PRODUCT/PROCESS CHANGE NOTICE (PCN)

PCN #: A1301-08 DATE: February 5, 2013 Product Affected: 3.0mm x 3.0mm VFQFPN-20 4.0mm x 4.0mm VFQFPN-24 4.0mm x 4.0mm VFQFPN-28 (Refer to Attachment 2) Date Effective: May 5, 2013	MEANS OF DISTINGUISHING CHANGED DEVICES: <input type="checkbox"/> Product Mark <input type="checkbox"/> Back Mark <input type="checkbox"/> Date Code Assembly lot marked on the device provides traceability to the material used <input checked="" type="checkbox"/> Other
--	---

PCN Type: Assembly Process and Material Change

Figure 1: Illustration of Interposer Inserted between top die and bottom die (Top View)

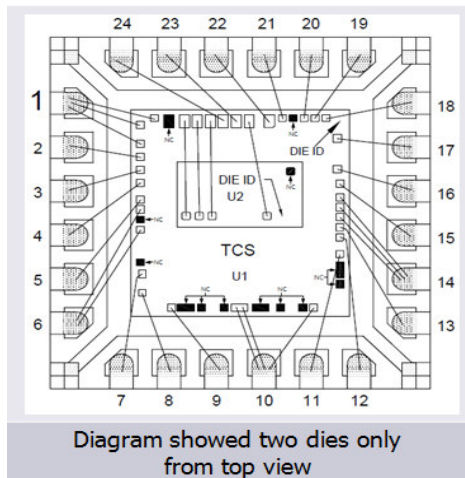
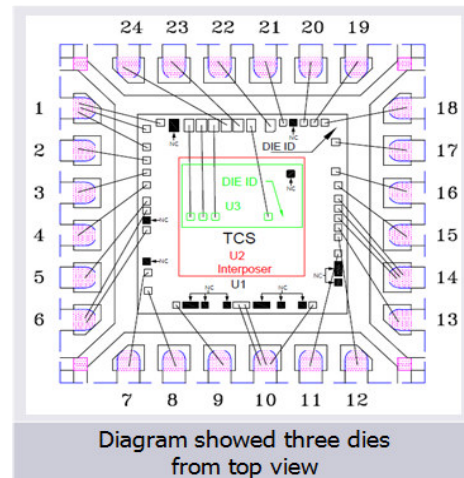
This notification is to advise our customers that IDT has successfully completed the qualification of stack die assembly with interposer. An interposer will be added in between the top die and the bottom die to improve assembly yield.

The die attach material for the top die will change to NEX-130SB-25 and for the bottom die to 8200T.
